Rezoning Application:

PD 23-0257

1.0 APPLICATION SUMMARY

Applicant: Todd Pressman
 FLU Category: Suburban Mixed Use-6
 Service Area: Urban
 Site Acreage: +/- 2.49 acres
 Community Plan Area: Brandon
 Overlay: None
 Request: Rezone from ASC-1 to PD

2.4 Proposed Site Plan (partial provided below for size and orientation purposes. See Section 8.0 for full site plan)

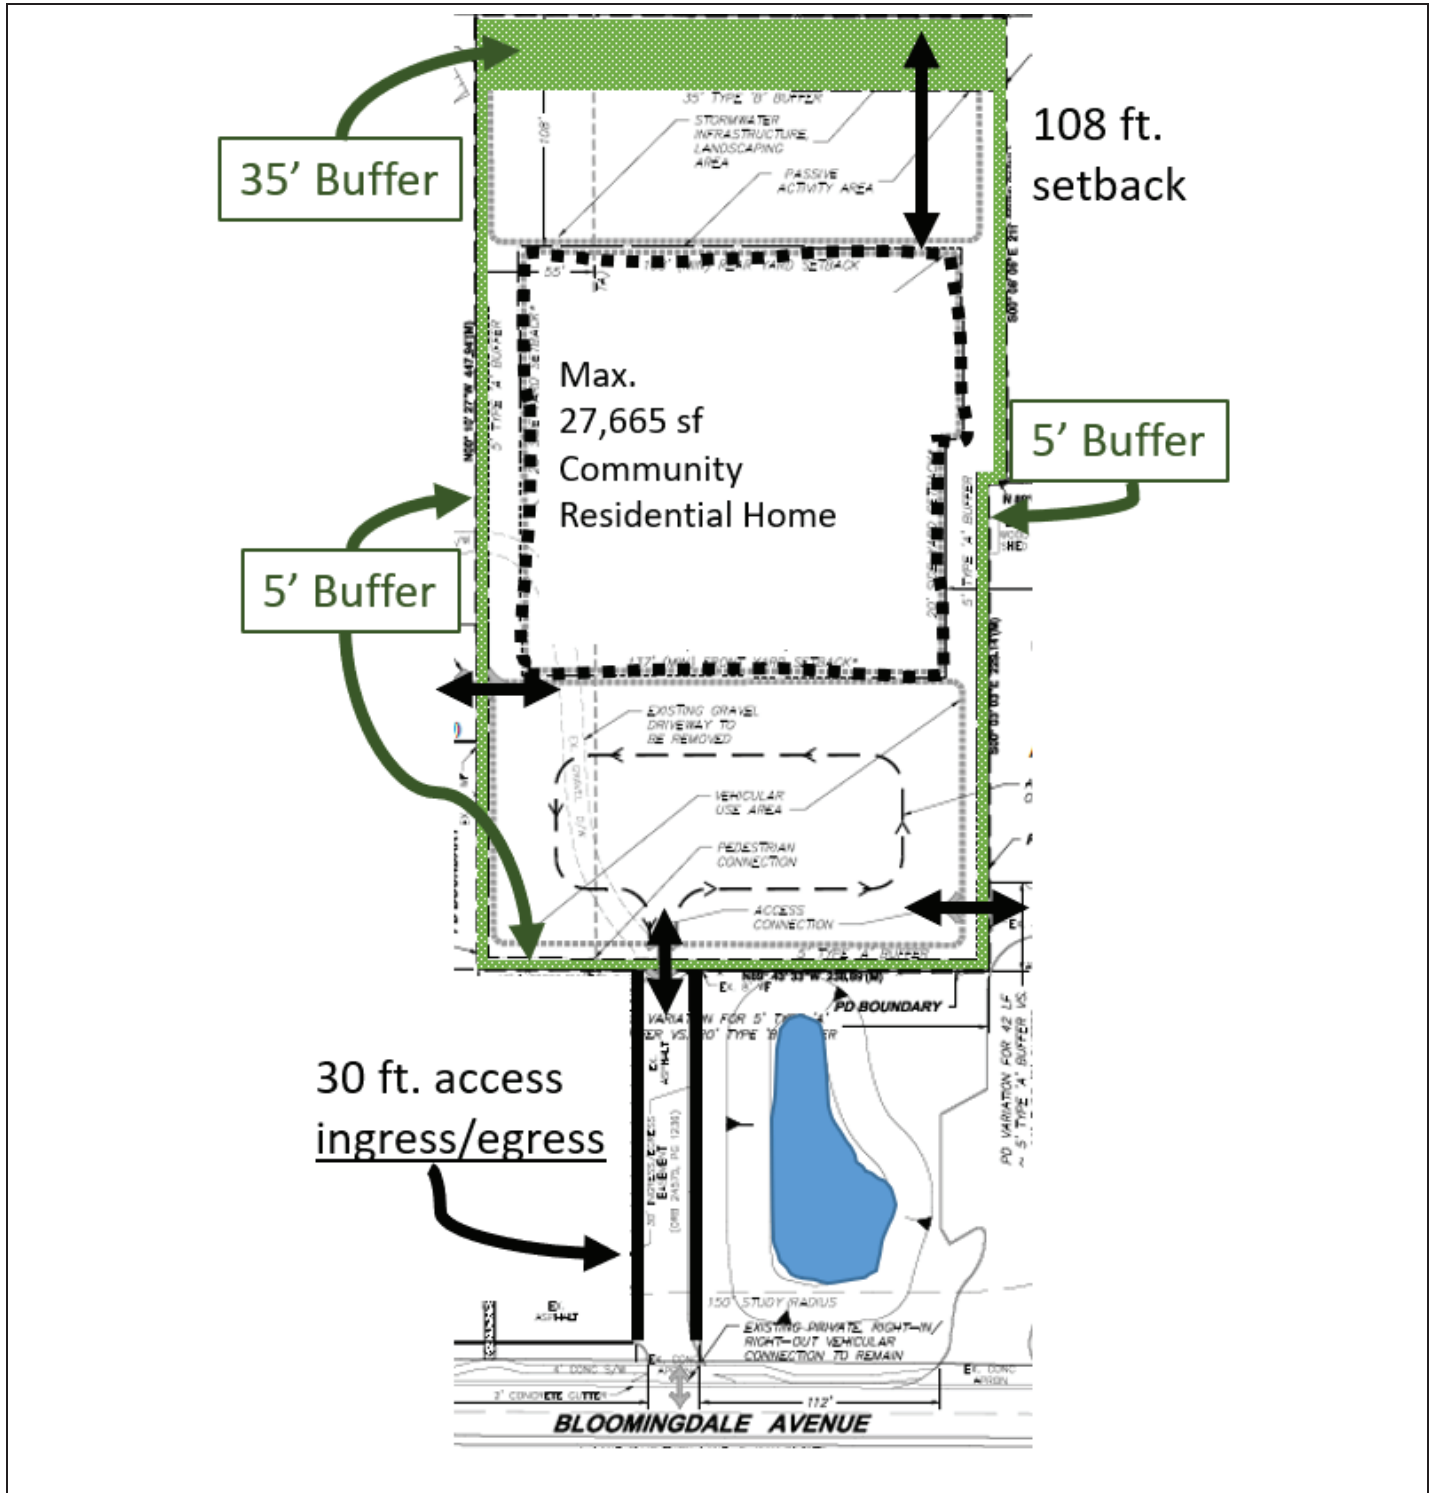
Prior to site plan certification the following needs to be revised:

- Remove the portion of the stormwater pond that is located within the 35-foot buffer area on the northern property boundary.
- The site plan shall be updated to revise the “25,860” sf shown on the site plan to “27,665” sf as shown in the site data table.
- Add note on the site plan that states “Sidewalks to be provided per the LDC”.
- Revise the site plan to show a crosswalk in the location where the sidewalk connection crosses the drive aisle.

2.4 Proposed Site Plan (partial provided below for size and orientation purposes. See Section 8.0 for full site plan)

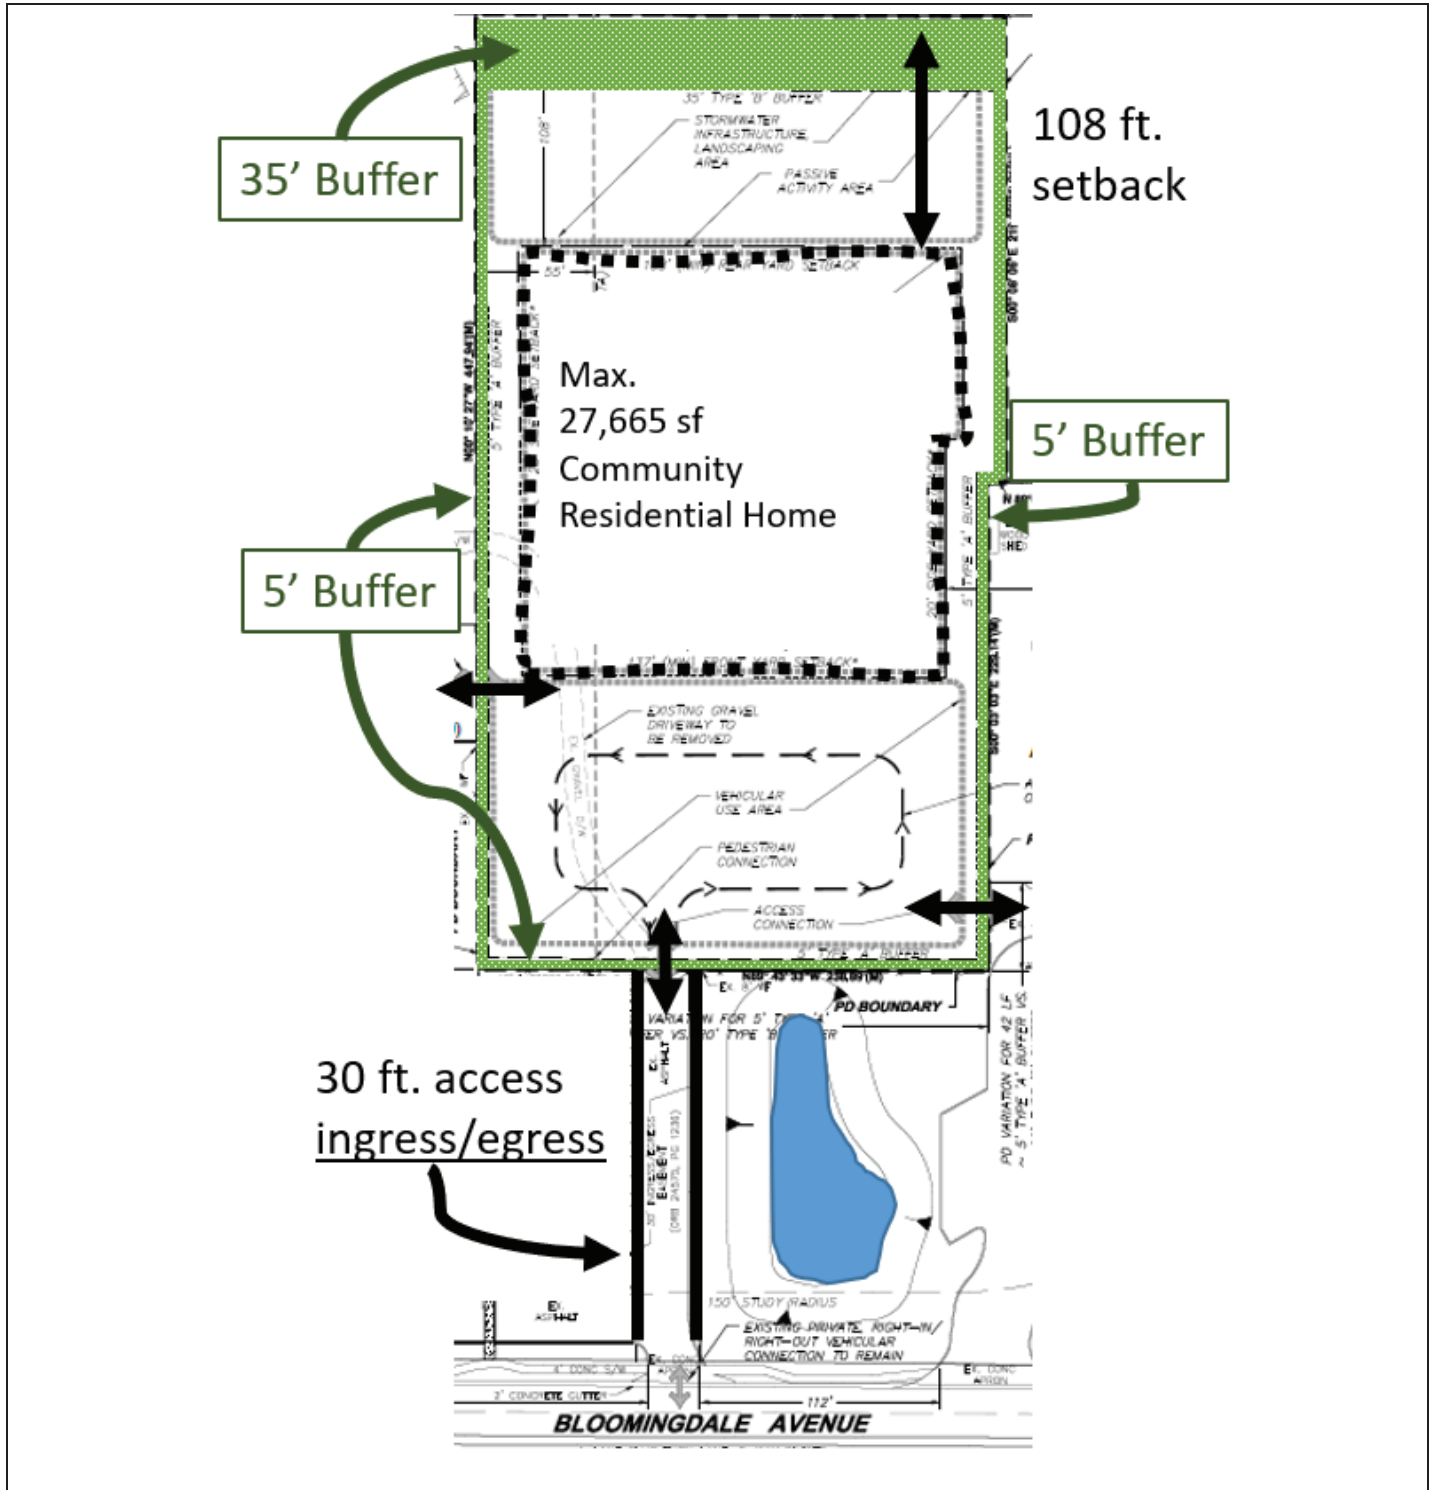
Prior to site plan certification the following needs to be revised:

- Remove the portion of the stormwater pond that is located within the 35-foot buffer area on the northern property boundary.
- The site plan shall be updated to revise the “25,860” sf shown on the site plan to “27,665” sf as shown in the site data table.
- Add note on the site plan that states “Sidewalks to be provided per the LDC”.
- Revise the site plan to show a crosswalk in the location where the sidewalk connection crosses the drive aisle.
